**ON-SITE SEWAGE DISPOSAL SYSTEM
HOWARD COUNTY HEALTH DEPARTMENT
BUREAU OF ENVIRONMENTAL HEALTH**

ADDRESS: 14715 Dorsey Mill Road PROPERTY OWNER: Geyer

Re: Building permit application for addition to residential home

NEW 1 STORY ADDITION

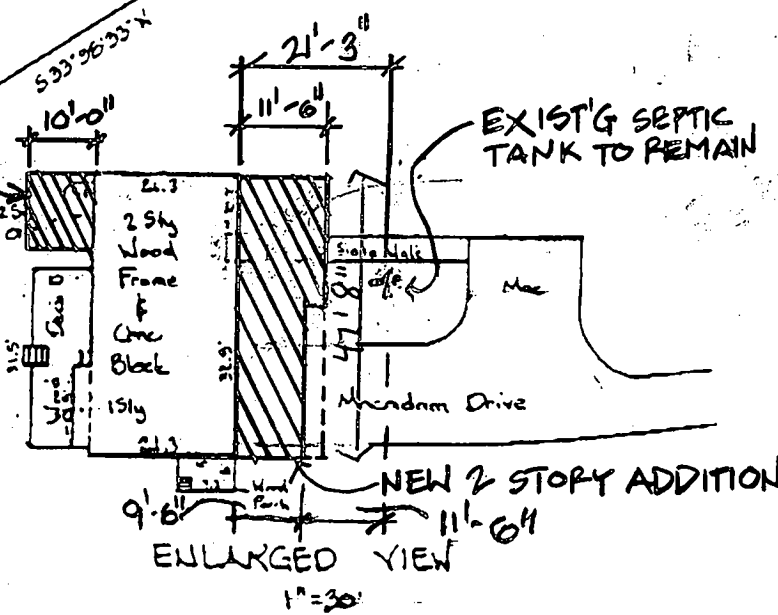
TO Scale, setbacks met,
Aest. wal. by Fogles
OK

However, the septic tank is located right in front of an exterior porch and step and it seems the step will need to come within 8 feet of the septic tank. (Your recommendation had been 8.) There doesn't seem to be any way to avoid this situation without completely upending the addition plans. Therefore I am requesting to have a distance of 8 feet approved, with the understanding that if the septic tank should need to be serviced or moved or replaced that a portion of the step or porch may need to be removed.

BP OK
BP# ??
(KN)
